UNITED STATES PATENT AND TRADEMARK OFFICE

10/560,244

Office Action Summary	Application No. 10/560,244	Applicant(s) KASHIHARA ET AL.	
	Examiner KARL I.E. TAMAI	Art Unit 2834

DETAILED ACTION

Fujita figure 1.

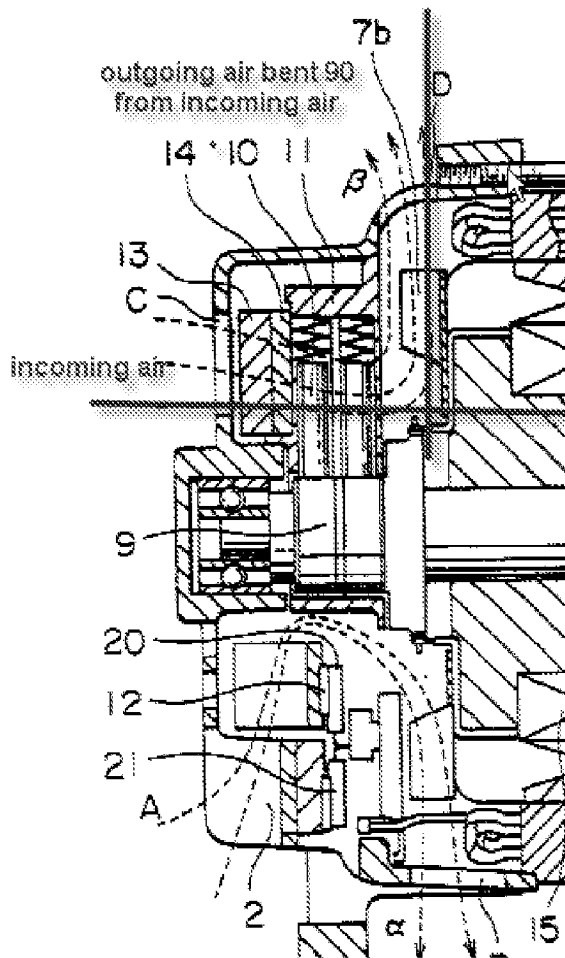
7. Claims 1, 3, 4, and 7 are rejected under 35 U.S.C. 102(b) as being anticipated by Fujita et al. (Fujita)(US 2002/0043886) and Oohashi et al. (Oohashi)(US 2003/0015932). Fujita teaches a generator for a vehicle having a rotor 6 with a field windings 15, a stator including a stator core 17 arranged opposed to the rotor and an electrical conductor wound 18 on the stator core, and a housing 3 supporting the rotor and the stator. Fujita teaches the stator core 17 is constituted by core having a plurality of slots (see figure 3) each extending to an axial direction, the electrical conductor is comprised of a rectangular slot-in portion 18a located in the slots and a circular cross-over portion 18b connecting each of the slot-in portions at the shaft end side of the stator, wherein the conductor 18 is formed so that of-the slot-in portion 18a located in the slots is molded to substantially rectangular (in the press dies 102a, 102b of figure 14) in its cross-sectional profile before it is entered in the slots and the conductor of the cross-over portion 18b is substantially circular in its cross-sectional profile. Fujita teaches longer side portion of the conductor (radial side) of the slot-in portion located in

the slots has an insulation coating of which thickness is smaller than that of insulation coating in the cross-over portion due to the insulating resin coating of embodiment 9 (figure 12). Fujita teaches the longer side being in the radial direction and shorter side in the circumferential direction in order to increase output by reducing the chances of magnet saturation. Fujita teaches the core 17 directly connected to the housing 3 being endbrackets 1, 2 (see figure 1) protecting the conductors. Fujita teaches the blades bending the incoming air at a right angle (see figure 1, as annotated and shown below). Fujita teaches every aspect of the invention except it does not teach the core being laminated. Oohashi teaches the core 11 being laminated for easy insertion of the winding 60 (paragraphs 0035-0036) with a rectangular cross section at the in slot portions 16 and circular cross over portions 17. Oohashi (embodiment 7) teaches the rectangular portions are molded by pressing in a jig, the insulation is compressed to be thinner than the round end sections (shown in figures 23A and 23B). It would have been obvious to a person of ordinary skill in the art at the time of the invention to construct the alternator of Fujita with the stator core being laminated to provide easy assembly with a superior rate of production, as taught by Oohashi.
